From: Robert Reineke <rreineke@ksinghengineering.com>
Sent: Saturday, September 3, 2022 8:11 AM
To: Moll, John G - DNR (Gregory); shane@roerscompanies.com
Cc: Daniel Pelczar; Pfeiffer, Jane K - DNR
Subject: RE: Community Within The Corridor - East Block, BRRTS #07-41-590208 and #02-41-263675
Attachments: 0241263675_Historic Fill Exemption20220719.pdf; Engineered barrier details.pdf; Boring Logs_All.pdf; Figure 2 - Locations of Soil Probes, Monitoring Wells, Sub-Slab Vapor and Sub-Slab Soil Samples.pdf

From: Moll, John G - DNR (Gregory) <john.moll@wisconsin.gov>
Sent: Thursday, September 1, 2022 8:02 AM
To: shane@roerscompanies.com
Cc: Daniel Pelczar <dpelczar@ksinghengineering.com>; Robert Reineke <rreineke@ksinghengineering.com>; Pfeiffer, Jane K - DNR <jane.pfeiffer@wisconsin.gov>
Subject: Community Within The Corridor - East Block, BRRTS #07-41-590208 and #02-41-263675

SUBJECT : Development at Historic Fill Site or Licensed Landfill Exemption Application,
Form 4400-226 (R 05/16)
Community Within the Corridor Limited Partnership - East Block
2748 N. 32nd Street, Milwaukee, WI 53210
BRRTS #: 02-41-263675; FID #: 241025400

DRAWN BY: AMZ DATE: 01/29/2021
CHECKED BY: KVH DATE: 01/29/2021
SHEET TITLE: ENGINEERED BARRIER PLAN

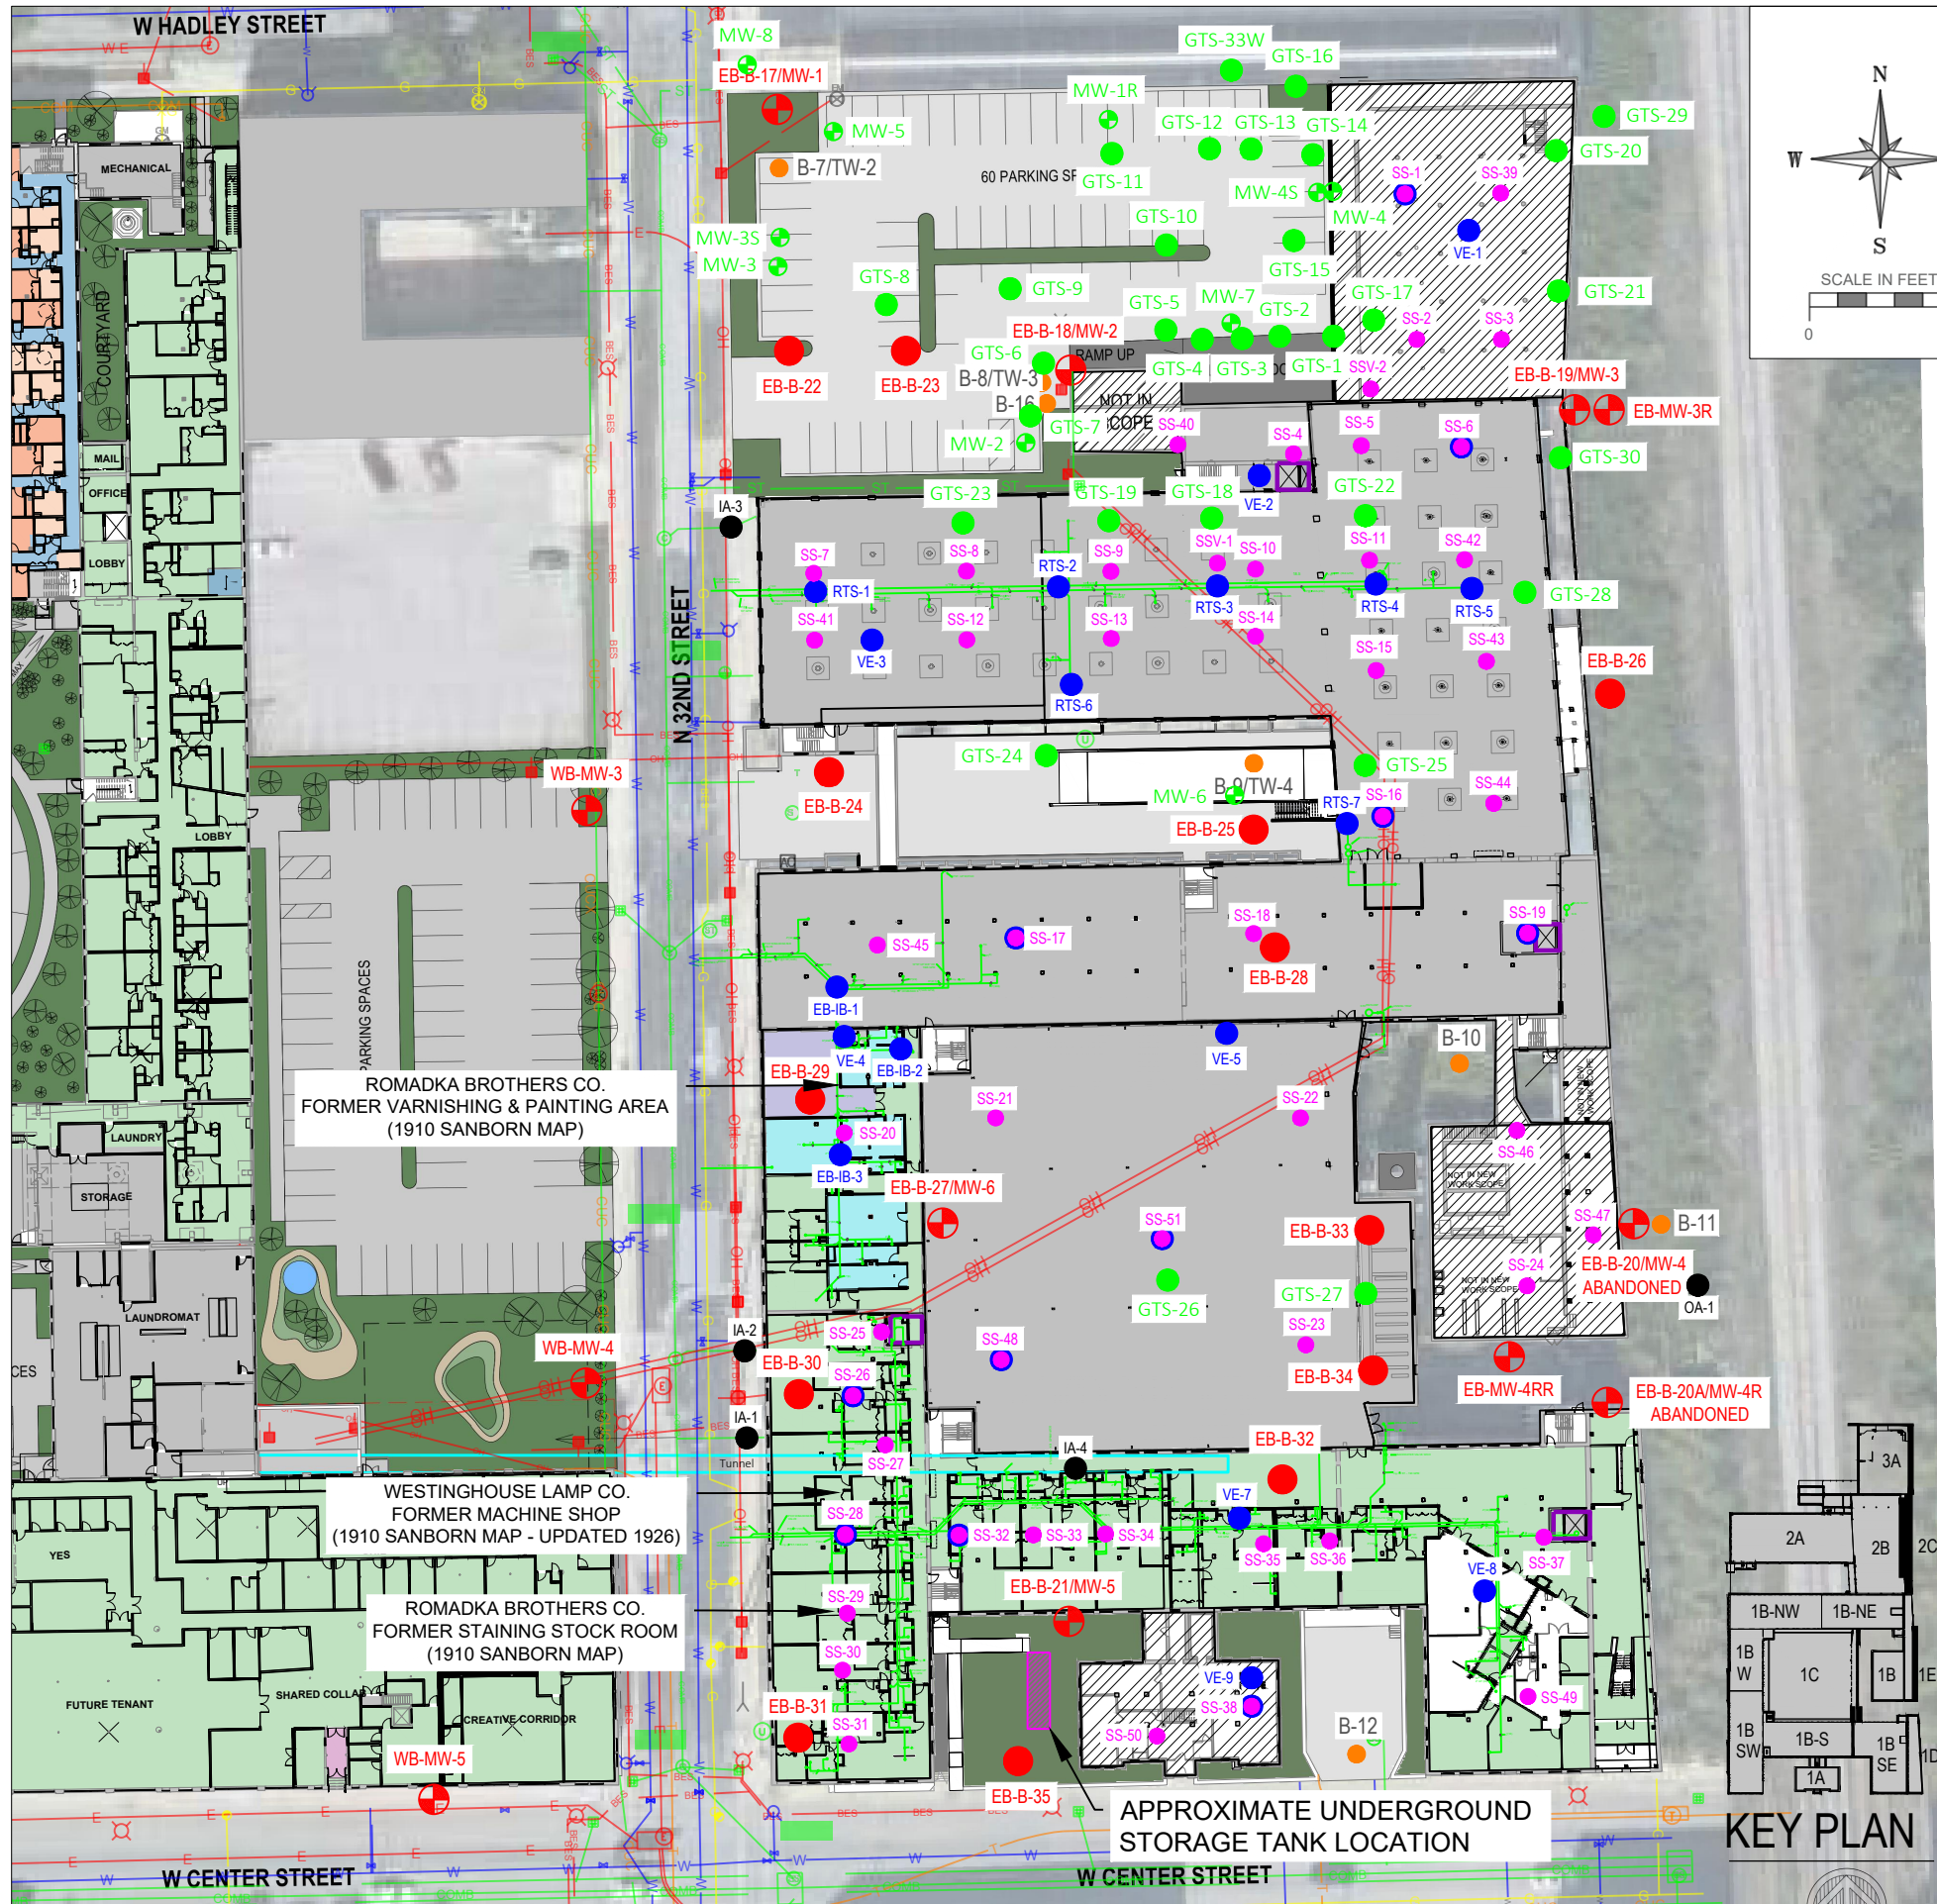
2. A figure needs to be provided with your application to show where the proposed building activities (new asphalt and concrete pavement, parking garage ramp, and landscaped areas) are located.

Please find attached Figures showing the engineered barrier locations and details. Please note that this was submitted to the WDNR on March 19, 2021 as part of the Update to Post Closure Modification Request / Remedial Action Plan.

FIGURE 2
 LOCATIONS OF SOIL PROBES, MONITORING WELLS, SUB-SLAB VAPOR AND SUB-SLAB SOIL SAMPLES

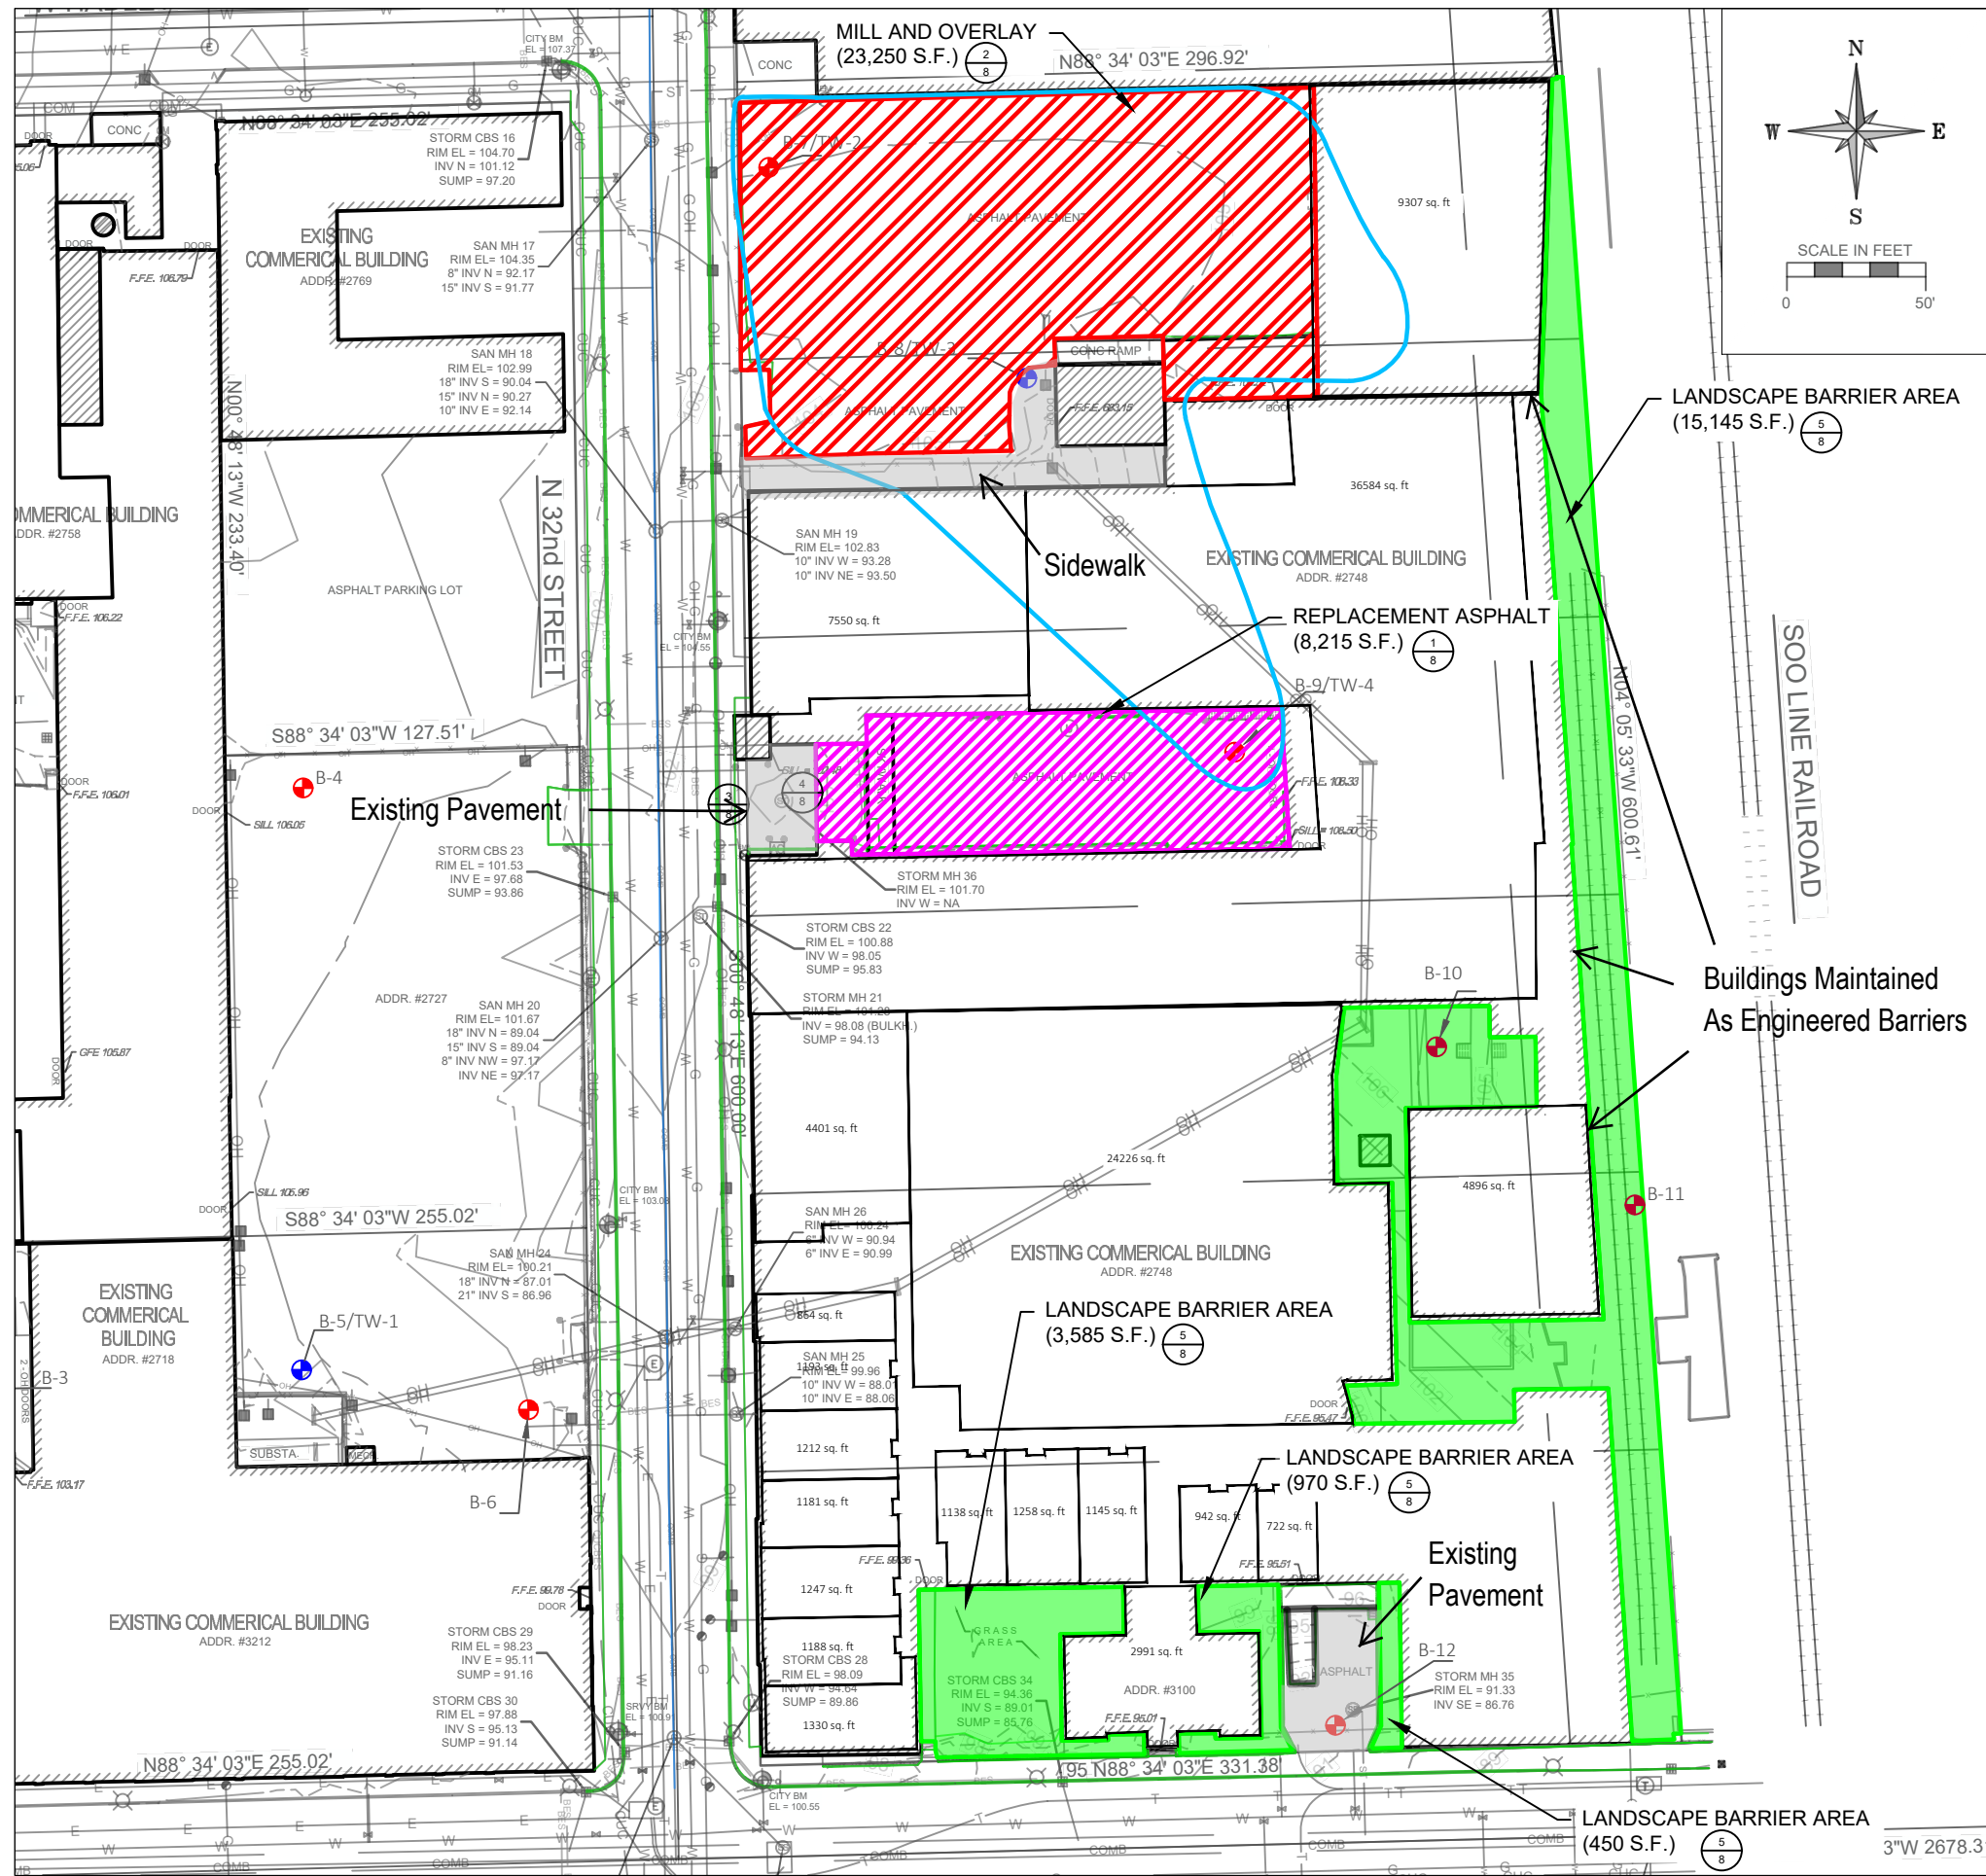
3. A methane assessment needs to be provided to determine whether the historic fill material or underlying undisturbed soil has the potential to generate methane gas. If the methane assessment does not include sampling for methane gas, an explanation needs to be provided for why the historic fill material and underlying soil do not present a risk for methane gas generation.

Please find attached the boring logs and a boring location map from the Site Investigation at the property. The boring logs demonstrate that subsurface soils consist of inorganic gravel, sand, silt, and clay. Peat and wood debris was not encountered in the subsurface. The material was called fill based on the presence of cinders, presumably from the former railroad spur on the property.

Further, soil samples were screened with an 11.7 eV PID capable of detecting methane. No indications of methane are present based on a consideration of the PID data and correlation of elevated readings with VOCs.

Therefore, the fill and underlying material is not methane producing.
